MIPS-PP-QA-14-R3-A  
TAC NO. ME4101

Subject: Babcock & Wilcox Technical Services Group, Inc., NRC Project 766 (TAC NO. ME4101), Submittal of the Published B&W TSG Nuclear Topical Report No. MIPS-PP-QA-14-R3-A, Medical Isotope Production System, Quality Assurance Program Description, Revision 3

**ATTACHMENT 1**  
**B&W RESPONSE – SUMMARY OF CLARITY CONCERNS**  
**REGARDING THE QUALITY ASSURANCE PROGRAM DESCRIPTION (QAPD)**  
**B&W MEDICAL ISOTOPE PRODUCTION SYSTEM (MIPS)**  
**TOPICAL REPORT MIPS-PP-QA-14**  
**PROJECT NO. 0766**  
**TAC NO. ME4101**

**Figure 1**

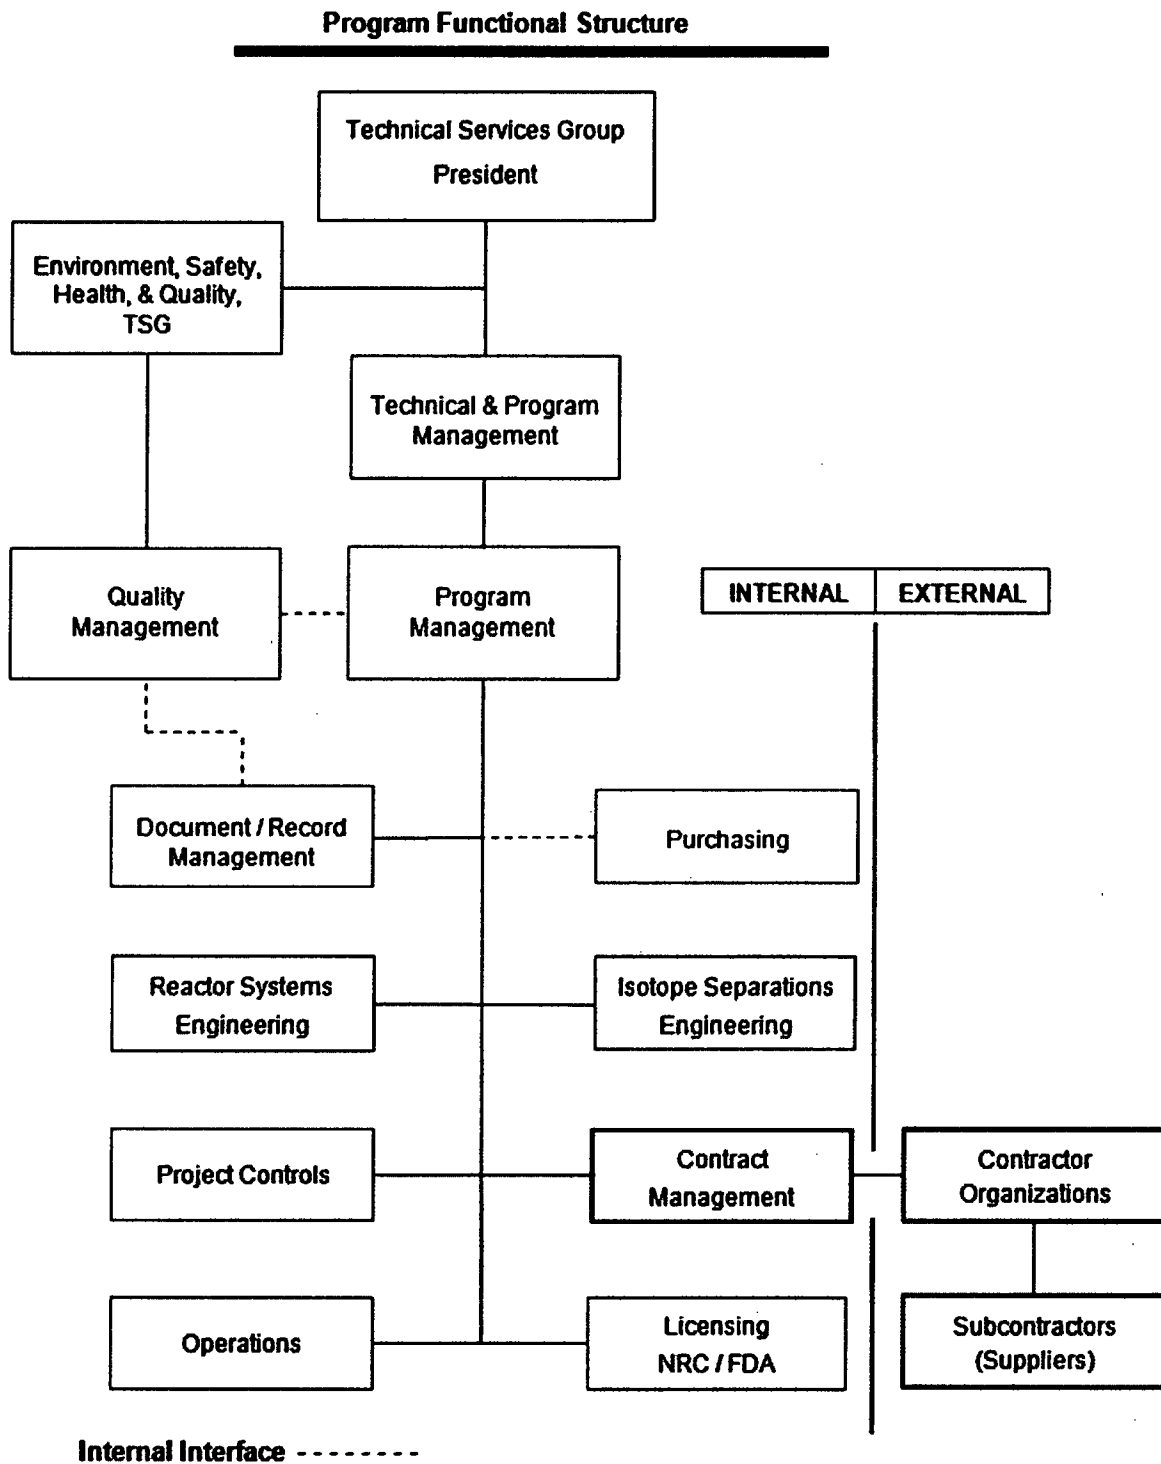
*B&W Response: Revision 2 of the QAPD as submitted to the NRC described an organization that included an Engineering / Procurement / Construction (EPC) contracting approach to the design and procurement services.*

*Concurrent with the clarification of the scope in the response to question 1 above, our description of the contracting approach now encompasses B&W management of multiple contractors. The organization chart Figure 1 and supporting paragraph 1.2.2.11 includes definitions of this broader generic approach to contract management.*
